RESPONSE TO SUBMISSIONS REPORT

ALEX AVENUE PUBLIC SCHOOL_SSD_9368

JUNE 2019
P4090
PREPARED FOR DEPARTMENT OF EDUCATION

Figure 2 - Indicative layout for temporary car park and drop-off zone

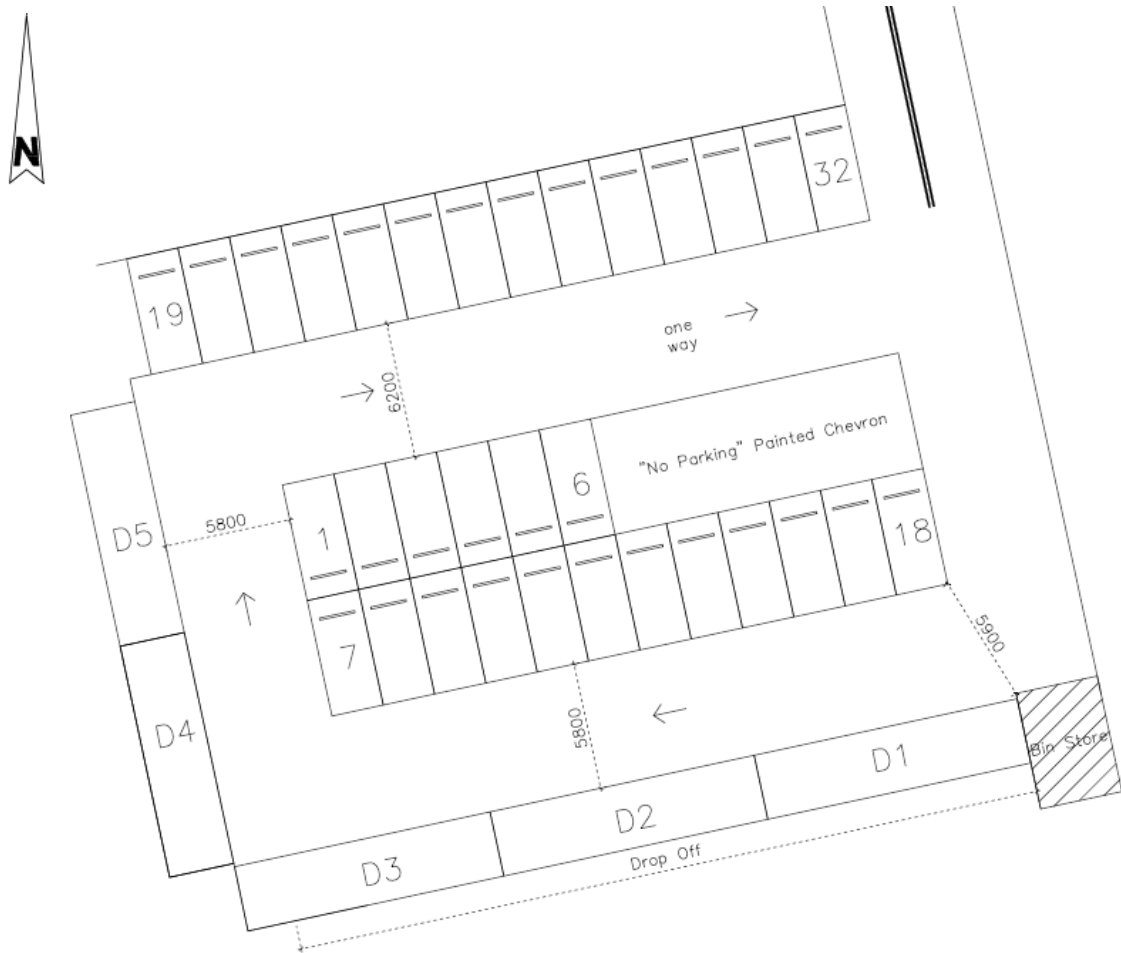
The amended proposal provides an indicative location for temporary onsite staff car parking and drop-off/pick up zone for Stage 1 of the School's operation. During Stage 1, the School is projected to serve a total of 400 students and 35 staff members. The temporary car park will only be needed if Council does not construct the adjacent car park in time for School opening. It will contain 32 staff car park spaces as well as provide a drop-off and pick-up zone capable of accommodating up to five (5) vehicle at any time.

Based on Stage 1 numbers, the temporary car park will require 39 spaces as per the Blacktown Growth Centres Precinct DCP. There is therefore a deficiency of seven (7) parking spaces per the parking requirements outlined in the DCP. This is found to be a necessary outcome due to constraints of the available site and the intention of providing a more flexible and smoother drop-off area. It is further recognised that while the DCP allows each staff member their own space, the mode share of primary school staff in the Blacktown LGA is not comprised entirely of private vehicles, therefore some leeway in parking demand is possible.

Figure 4 – Comparison of Original Site Ground Floor Plan (As Exhibited) and Amended Site Ground Floor Plan

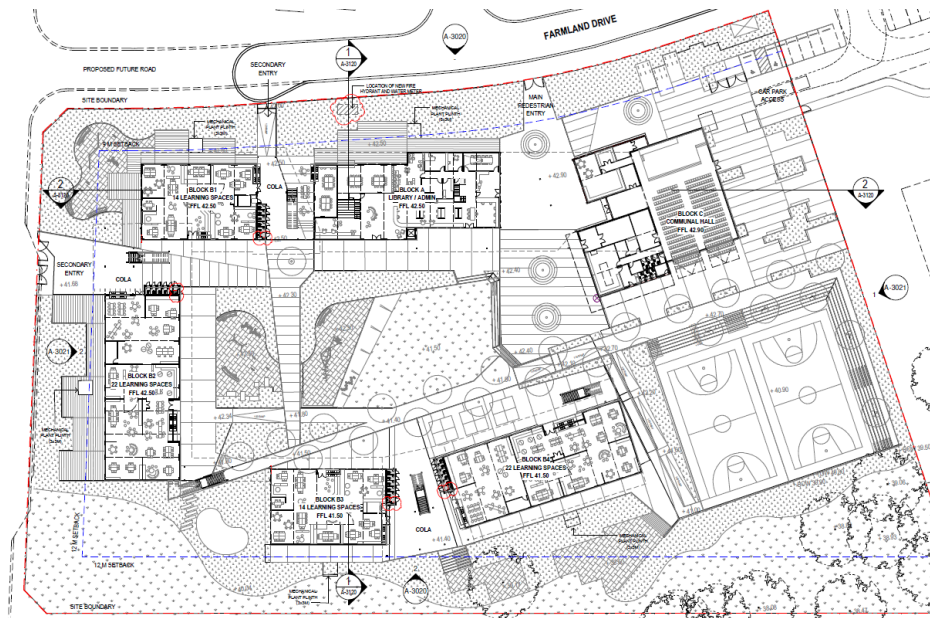
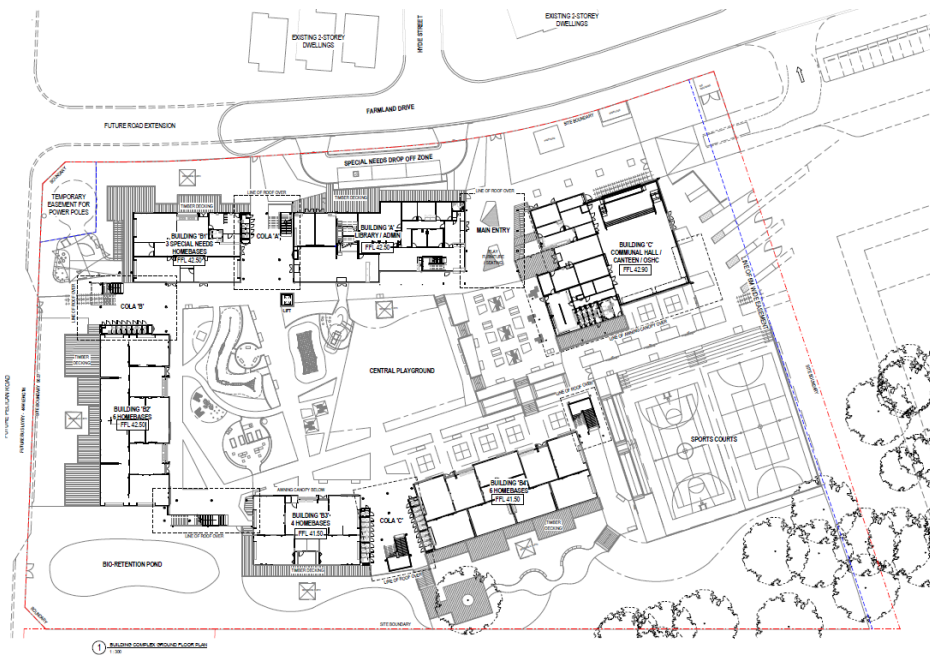
In accordance with Section 55 of the EP&A Regulations, the proposal seeks to make minor amendments to the proposed development. The amendments are a result of design development and in response to agency submissions. The following minor amendments to the original design (as exhibited) are proposed:

- Amendments to building design and internal floor layouts including relocation of external fire stairs and minor changes to the COLAs;
- Relocation of the special needs pick-up and drop-off zone to be contained wholly within the School boundary;

- Relocation of bicycle storage areas to adjacent to the school hall building; and
- Relocation of hydrant booster pump room within the Farmland Drive frontage.
